Randwick Local Planning Panel (Electronic) Meeting

Development Application Report No. D60/24

Subject: 8 Victory Street, Clovelly (DA/957/2023)

Proposal:	Demolition of existing structures and construction of a 2 storey dwelling with basement parking, swimming pool and landscaping works
Ward:	North Ward
Applicant:	Mr B Babikian
Owner:	Mrs R L Amirian & Mr D Amirian
Cost of works:	\$3,245,000.00
Reason for referral:	The development involves demolition of a local heritage item.

Figure 27: Proposed ground floor plan (in red) of the Torrens section of the site overlay basement level (in green), with Council markings of DSPA (in blue) and those DSPA not counted (in pink) - 8 Victory Street, Clovelly (*BJB Architects Pty Ltd*)

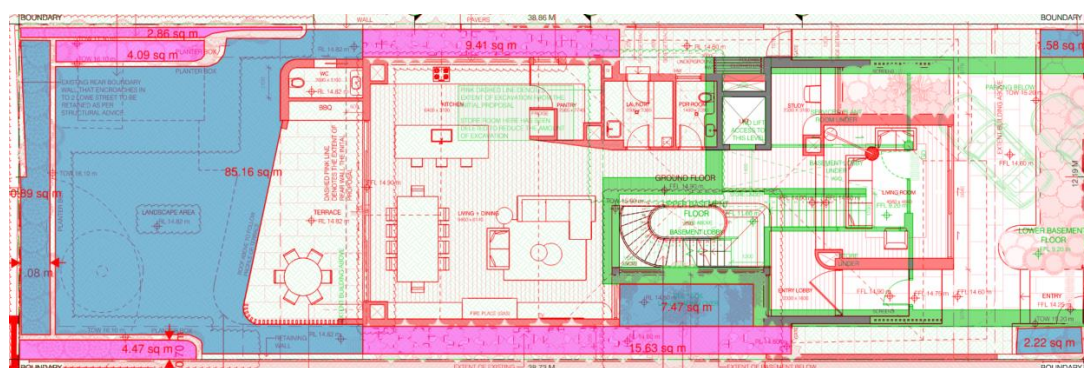
- The total of the Torrens section site area is 473.1m². The applicant has calculated the DSPA in this section as 31.6% (or 149.3m²) of the Torrens section. However, this calculation includes areas of planting <900mm in width, paved sleeper areas with groundcover in between and areas occupied by retaining walls as identified on the landscape calculation plan, which does not satisfy the DSPA definition in the RDCP.

Subsequently, Council has calculated the area this area as 22.7% (or 107.3m²) of the Torrens section. See Figure 27 below.

The proposal is recommended for approval subject to non-standard conditions that require an increase in the amount of deep soil permeable areas on the site, increase side and rear setbacks, redesign and further detailing to the upper Stratum garden terrace for greater consistency with the surrounding foreshore area.

Figure 28: Proposed ground floor plan (in red) of the Stratum section of the site overlay basement level (in green), with Council markings deep soil areas (in blue) and those areas not counted (in pink) - 8 Victory Street, Clovelly (*BJB Architects Pty Ltd*)

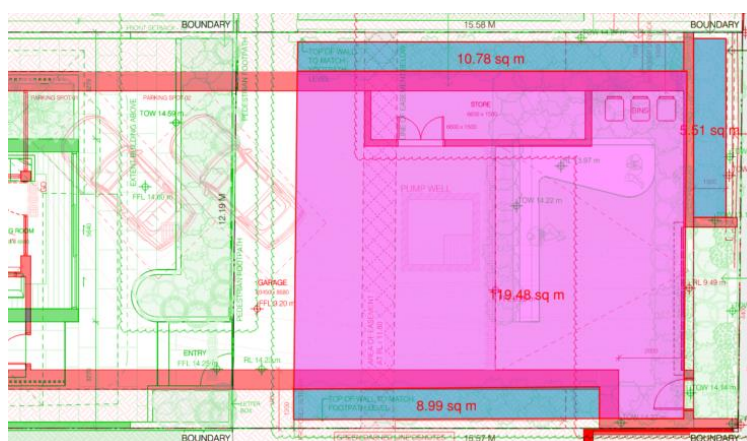
Subsequently, Council has calculated the area this area as 10.4% (or 19.8m²) of the Stratum section. See Figure 28 below.

Figure 29: Proposed eastern elevation with Council markings showing the side setback controls in blue – 8 Victory Street, Clovelly (*BJB Architects Pty Ltd*)

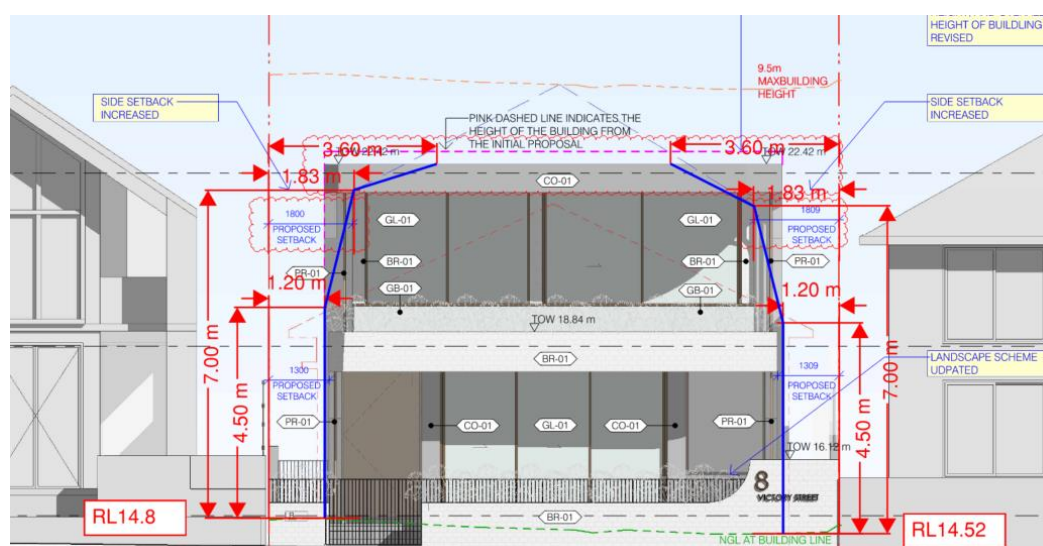
The proposed dwelling includes a portion of the ground floor external walls that are only setback 1.109m from the northern and southern side boundaries. Furthermore, between 4.5m-7.9m, the proposed dwelling is only setback 1.2m from the site boundaries to each side. The variations have been demonstrated in elevation form, as per Figure 29 and 30 below:

As per Figure 29 & 30 above, the dwelling does not comply with the DCP side setback controls.

Figure 31: Proposed dwelling first floor plan with setbacks marked in red - 8 Victory Street, Clovelly (Source: BJB Architects Pty Ltd)

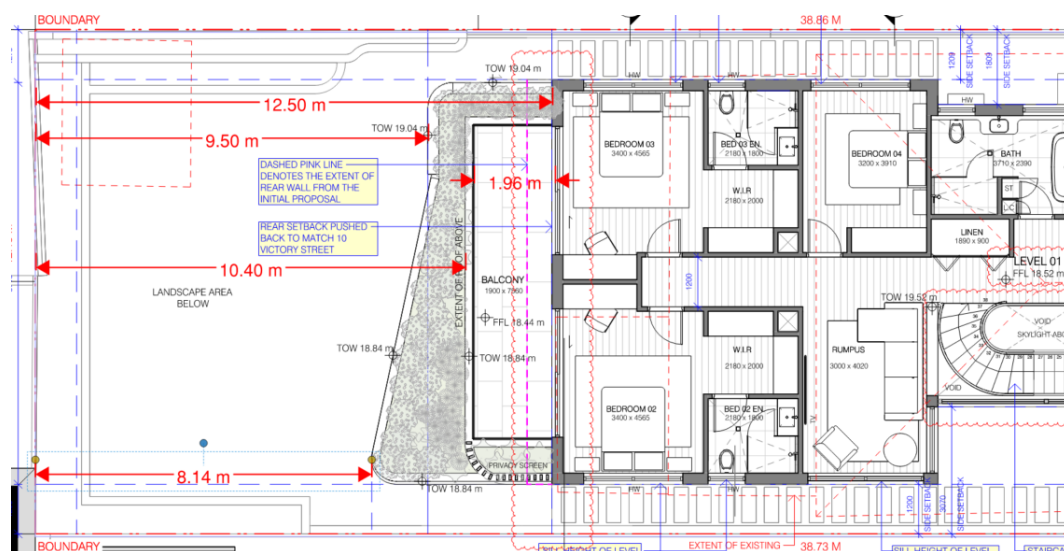
- 10.4m to the balcony;
- 12.5m to the dwelling rear façade.

Therefore, the proposed development complies with the numerical control of 8m. However, in accordance with control 3.3.3(ii) of the DCP, consideration is required of the above raised matters, in particular the existing predominant rear setback line in the subject urban block.

Figure 33: Proposed front long section with Council markings showing the extent of the proposed earthworks - 8 Victory Street, Clovelly (Source: BJB Architects Pty Ltd)

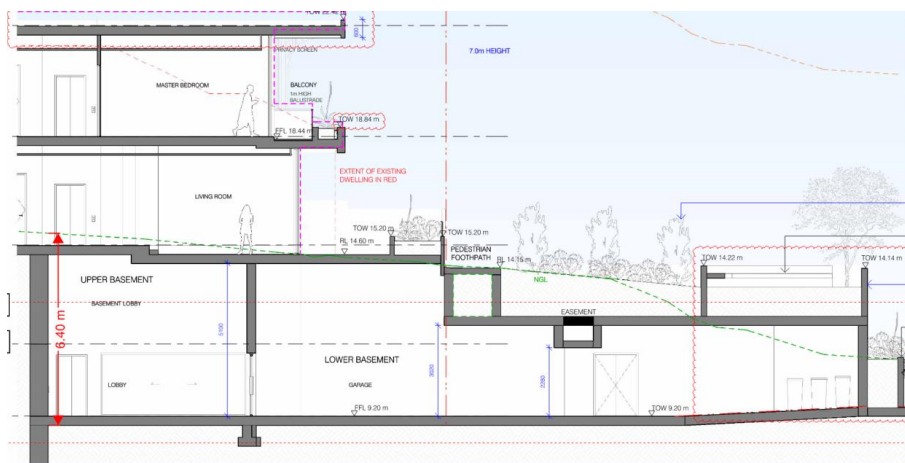
The proposed development also seeks to create a flat site for the main dwelling and rear POS area. The proposed dwelling has a minimal split-level design with a difference of only 300mm between the front and rear sections of the ground floor level (being RL14.6 and RL14.9). This significant amount of excavation will result in retaining walls having to be provided along the side and rear boundaries to height of approximately 2.2m, with planters forward of the wall sections to reduce the visual impact. See Figure 33 below.

Figure 39: Proposed upper terrace level with Council markings showing the conditioned two tiered terrace gardens - 8 Victory Street, Clovelly (Source: BJB Architects Pty Ltd)

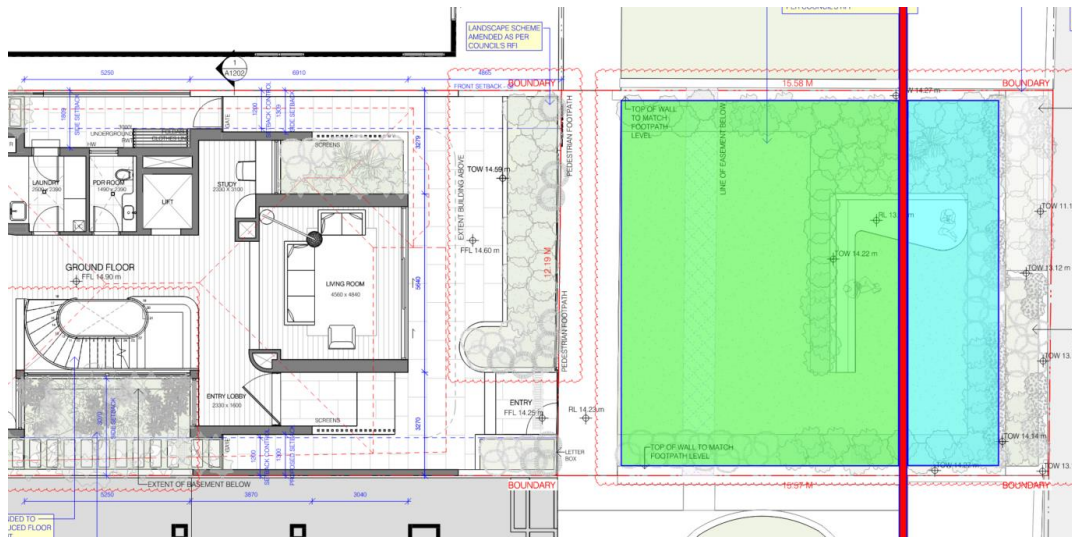
Council is concerned that the terrace garden does not integrate well into the adjoining structures and retain the similar features of the terraces within this block. As the upper Stratum section (above RL13.00) is owned by Council, a separate Civil Works application will be required to be submitted and approved by Council for all works. In order to provide a more integrated and less imposing design within the foreshore area, the following considerations have been made and conditions of consent recommended to be included in the Civil Works application design:

Figure 13 & 14: 3D oblique of the proposed development showing the extent of non-compliance with the side setback controls of the subject site (Source: MDNHUnion)

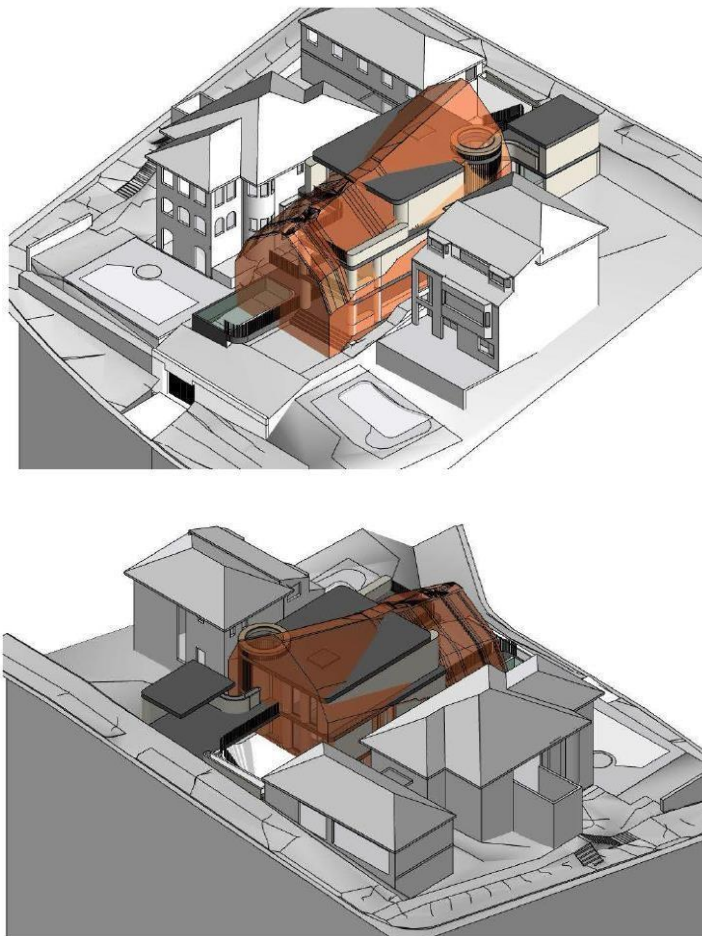
Figures 13 and 14 below demonstrate the extent of the non-compliance with the side setback controls, particularly that of the rear portion of the ground floor and near entirety of the first floor.

The non-compliant side setbacks are inconsistent with the objectives of Part C1, Section 3.2.2 of the RDCP 2023 and will result in the following adverse impacts:
